C.J. SMALL SUBDIVISION NUMBER 3

APPLICATION NUMBER 8 DATE December 21, 2017

APPLICANT C.J. Small Subdivision No. 3

REQUEST Subdivision

DETAIL SITE PLAN

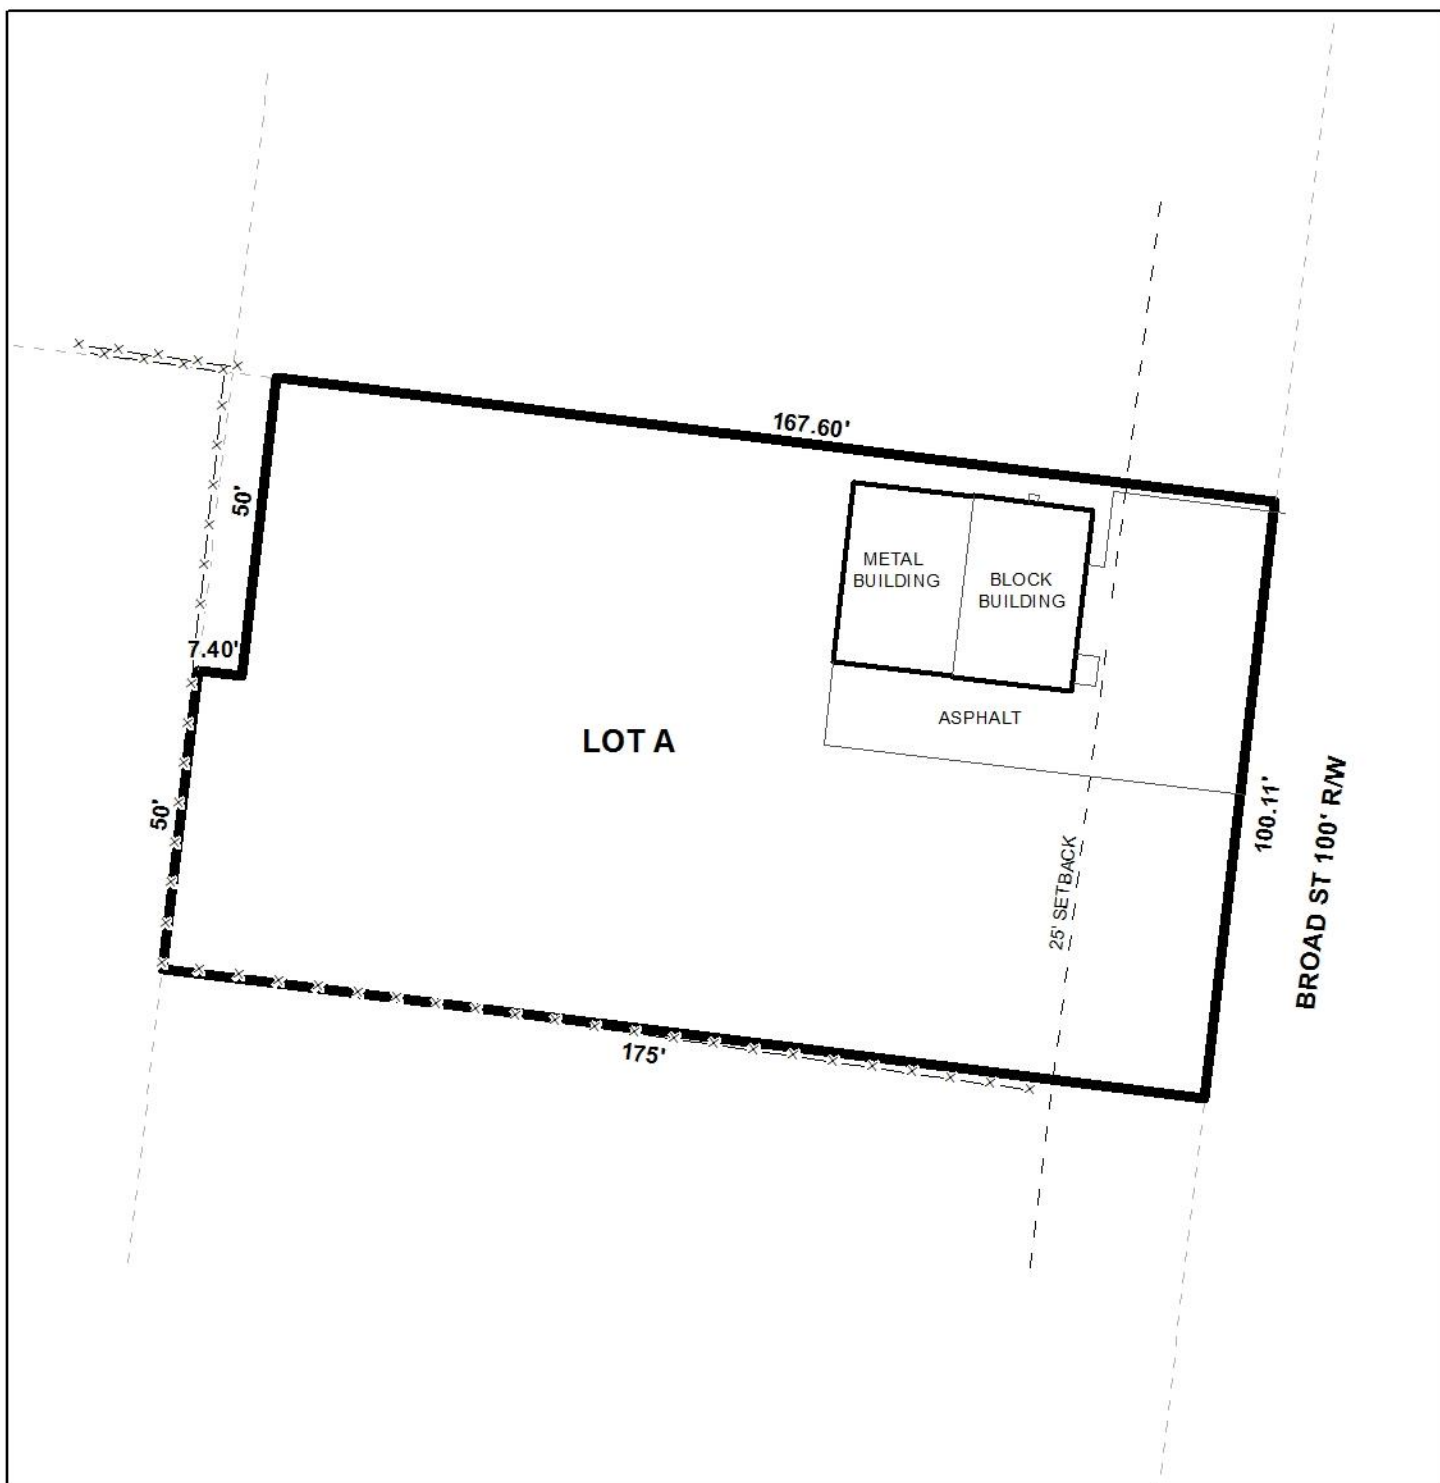
The proposed lot fronts South Broad Street, a major street on the Major Street Plan. As a major street, South Broad Street requires a 100' right-of-way width. The preliminary plat illustrates compliant 100' right-of-way width to South Broad Street and, if approved, should be retained on the Final Plat.

A 25-foot minimum building setback line is depicted on the preliminary plat along South Broad Street. If approved, the 25' setback along South Broad Street should be retained on the Final Plat.

The proposed Lot A exceeds the 7,200 square foot minimum lot size requirements for lots served by public water and sanitary sewer systems. The preliminary plat provides the lot sizes in both

square feet and acres and if approved, the lot size information should be retained in both square feet and acres on the Final Plat.

As a means of access management, a note should be placed on the Final Plat, if approved, stating that Lot A is limited to one curb cut to South Broad Street, with size, location and design to be approved by Traffic Engineering and conform to AASHTO standards.

- 1) Retention of the 25' minimum building setback line along South Broad Street;
- 2) Retention of the 100' right-of-way width for South Broad Street;
- 3) Retention of lot size information in both square feet and acres;

- 4) Placement of a note on the Final Plat stating that Lot A is limited to one curb cut to South Broad Street, with size, location and design to be approved by Traffic Engineering and conform to AASHTO standards;
